**Re: Inland Kenworth, 7711 Fortuna Rd. NW**  
**Certificate of Occupancy – Transportation Development**  
Administrative Amendment dated 09-17-13 (J10-D044)  
Certification dated 07-16-14

**Re: Inland Kenworth, Grading and Drainage Plan**  
**Engineer's Stamp 6-18-13 (J10/D044)**

**Re: Inland Kenworth, Grading and Drainage Plan**  
**Engineer's Stamp 5-29-13 (J10/D044)**

SUPPLEMENTAL/AMENDED INFORMATION  
TO DRAINAGE REPORT  
DATED APRIL 23, 2013

# INLAND KENWORTH ONSITE BASIN MAP

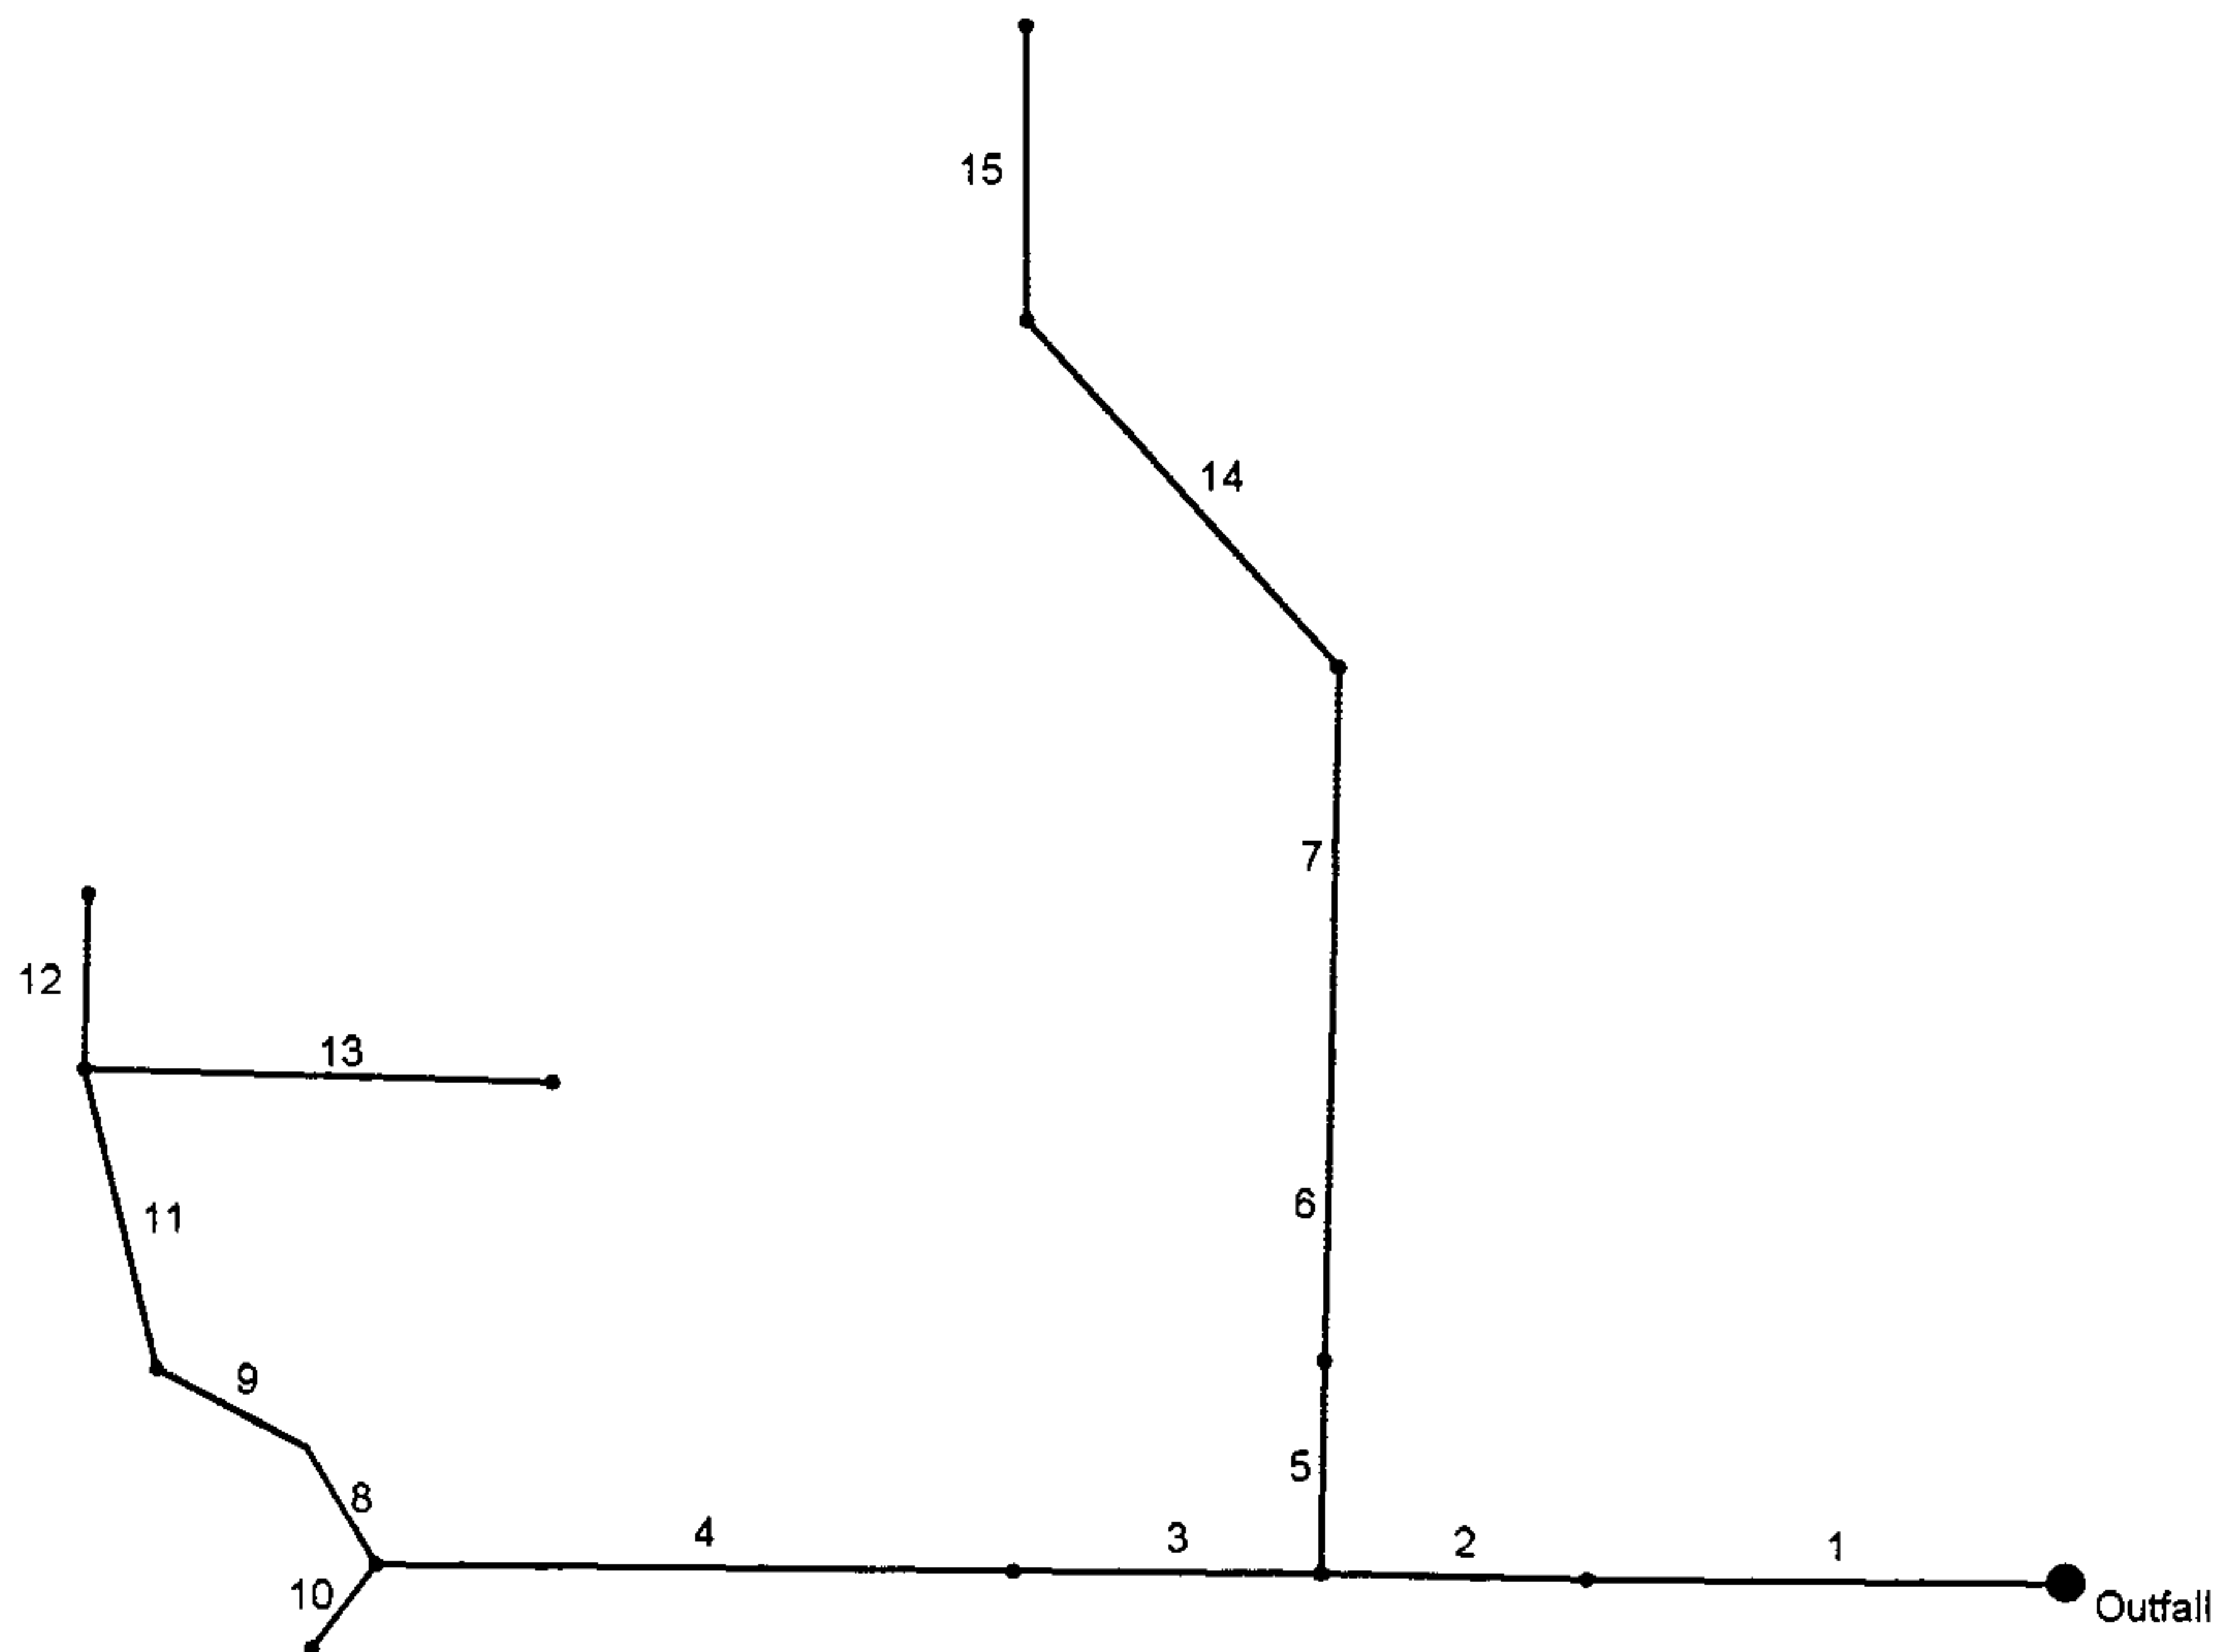
- 1) Two sheets are numbered CG-101.
- 2) Please include proposed flow lines and back of sidewalk elevations along Fortuna Rd.
- 3) Provide inlet capacity calculations. Assume 50% clogging factor in your calculations.
- 4) Add all the curb opening sizes on the plans.
- 5) Provide calculations for the channel located east side of Basin 2. Include a section for the channel on the plan. Can the runoff overflow the channel when making a 90 degree turn?
- 6) Add all the storm drain pipe sizes to the plan.
- 7) The runoff appears to be block at the north east corner of the property where the offsite runoff enters the site.
- 8) Based on the documents provided the allowable discharge is 3.76 cfs/ac. Therefore, the total discharge is (8.86 ac x 3.76 cfs/ac) 33.31 cfs, and the plan shows an allowable discharge of 34.60 cfs. Please clarify.

- Channel at east property line was eliminated and replaced with 2-Type C inlets and storm drain.
- Storm drain from inlet #1 was extended to pick up flows from loading dock area and roof drains.
- Onsite Basin Map (Appendix B) was revised.
- Hydraflow Storm Sewer Calculations (Appendix D) were revised.
- Inlet Capacity Calculations were added

- 1) A new grading plan is attached—Sheets CG-101, CG-102, CG-103 and CG-105.
- 2) Flowline and back of sidewalk grades along Fortuna are included.
- 3) Capacity calculations for inlets are included.
- 4) Curb opening sizes are included on plan.
- 5) Channel has been eliminated and replaced with 2-Type C inlets and storm drain.
